UNITED STATES PATENT AND TRADEMARK OFFICE

APPLICATION NO.	FILING DATE	FIRST NAMED INVENTOR	ATTORNEY DOCKET NO.	CONFIRMATION NO.
10/797,258	03/09/2004	Pankaj Mehra	200314264-1	5351

Office Action Summary	Application No. 10/797,258	Applicant(s) MEHRA ET AL	
	Examiner Cheryl Lewis	Art Unit 2167

DETAILED ACTION

Fig. 3

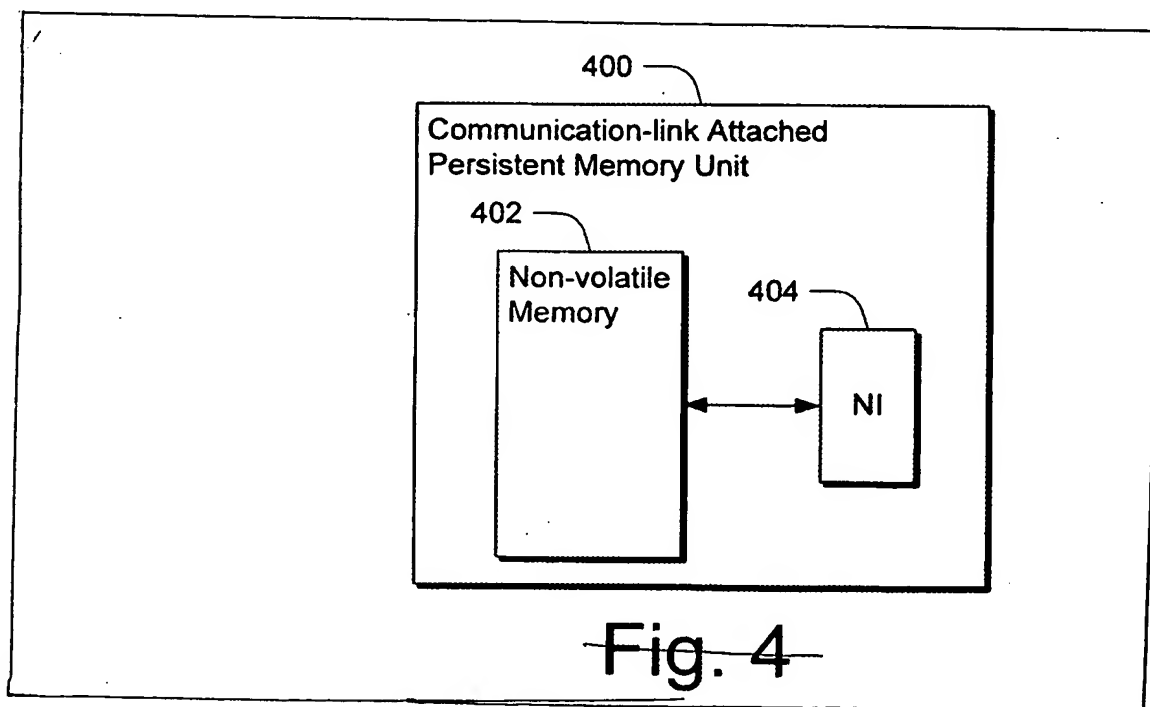
3. The drawings are objected to because drawing figures 3 and 4 depict a partial view of the drawing figures. A box and/or a line drawn around each individual drawing figure is needed to show each individual figure as a separate entity (MPEP 37 CFR 1.84(h)).

As a convenience to the applicants, the examiner has attached an amendment of drawing figures 3 and 4 to show by example, how to effectively amend drawing figures 3 and 4.

~~Fig. 3~~

~~Fig. 4~~

Corrected drawing sheets in compliance with 37 CFR 1.121(d) are required in reply to the Office action to avoid abandonment of the application. Any amended replacement drawing sheet should include all of the figures appearing on the immediate prior version of the sheet, even if only one figure is being amended. The figure or figure number of an amended drawing should not be labeled as "amended." If a drawing figure is to be
